CATEGORY 3 PLAN  
BEECHER TERRACE LIFELONG WELLNESS BUILDING - PHASE I  
OWNER/DEVELOPER  
LOUISVILLE METRO HOUSING AUTHORITY  
420 S. 10TH ST.  
LOUISVILLE, KENTUCKY 40203  
TEL: (502) 569-3400  
FAX: (502) 569-3400  
TRAC@METROKY.ORG

DRWN BY: MJL	CHKD BY: AD/BLB
DATE: OCT. 23, 2017	
DRAWING: CAT. 3	
SCALE: 1"=20'	
SHEET 1 OF 1

PLAN REVISIONS:

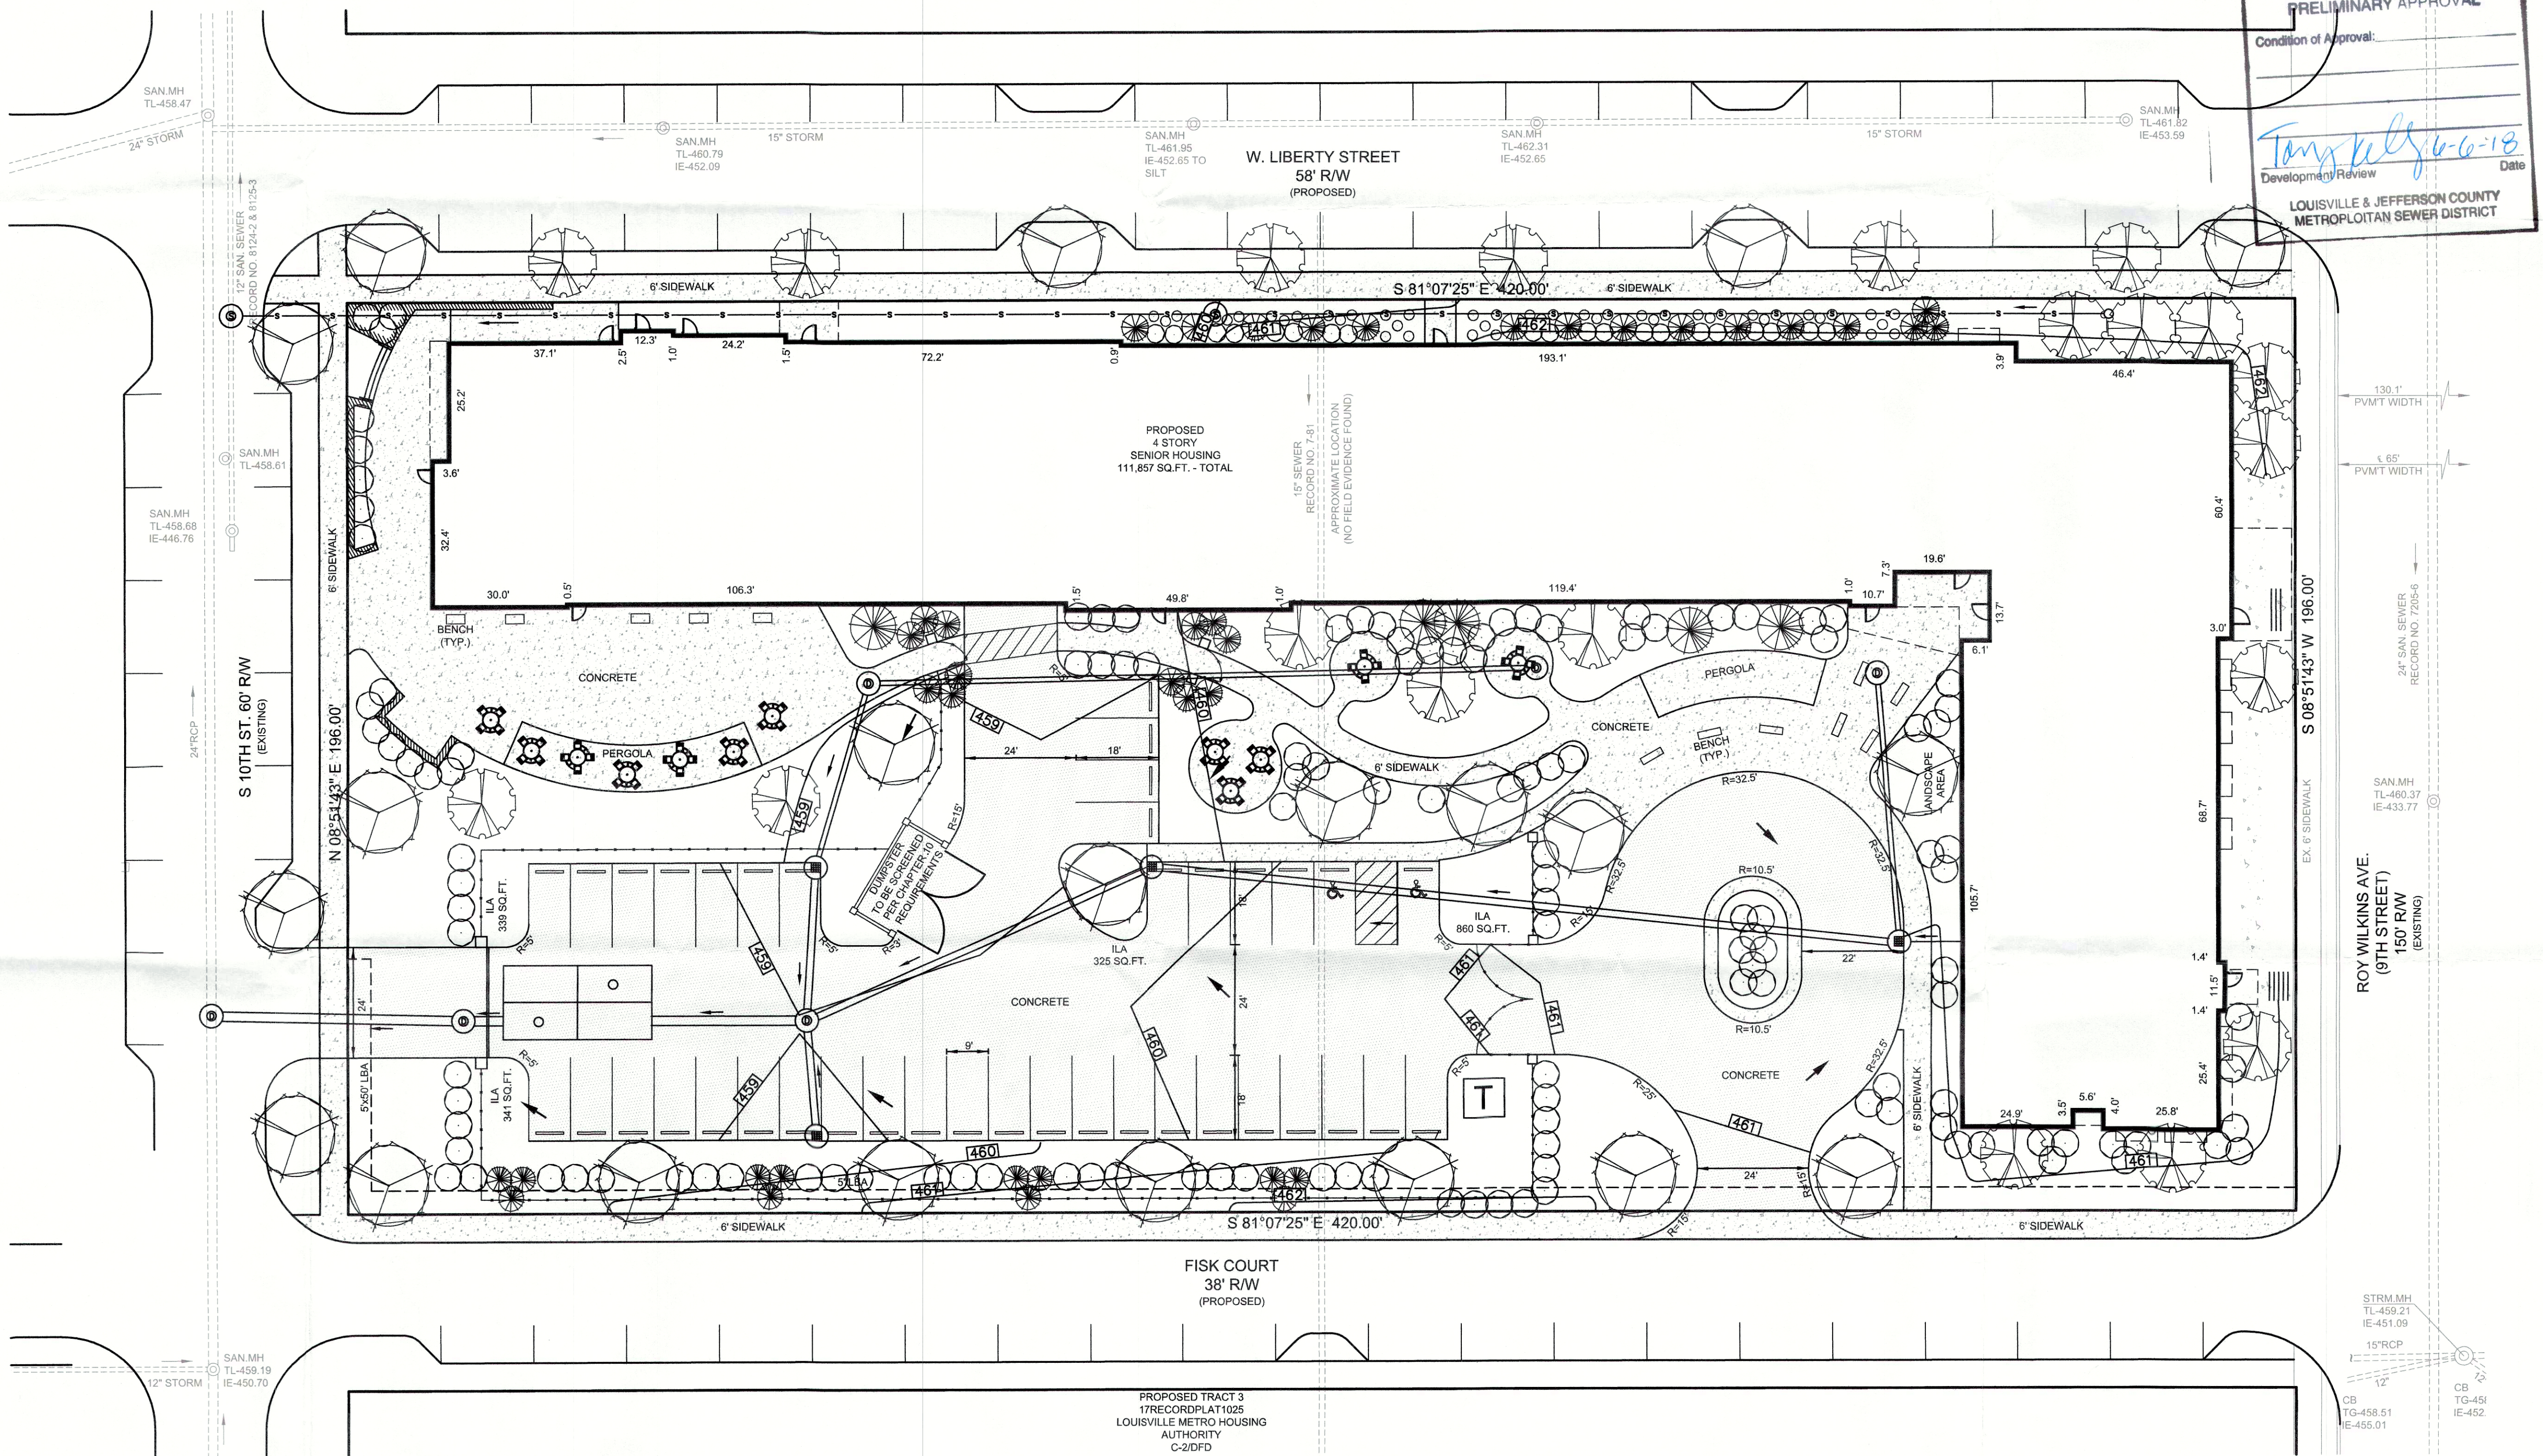
REVISIONS FROM THE ORIGINAL PLAN INCLUDE:

- ELIMINATION OF POOL/POOL HOUSE
- RECONFIGURATION OF ON-SITE PARKING WITH AN INCREASE OF 36 TO 39 SPACES
- REDUCTION IN NUMBER OF DWELLING UNITS FROM 120 TO 117.
- INCREASE IN BUILDING SIZE FROM 111,357 SQ.FT. TO 111,857 SQ.FT.
- ELIMINATION OF BALCONIES
- DECREASE IN VUA
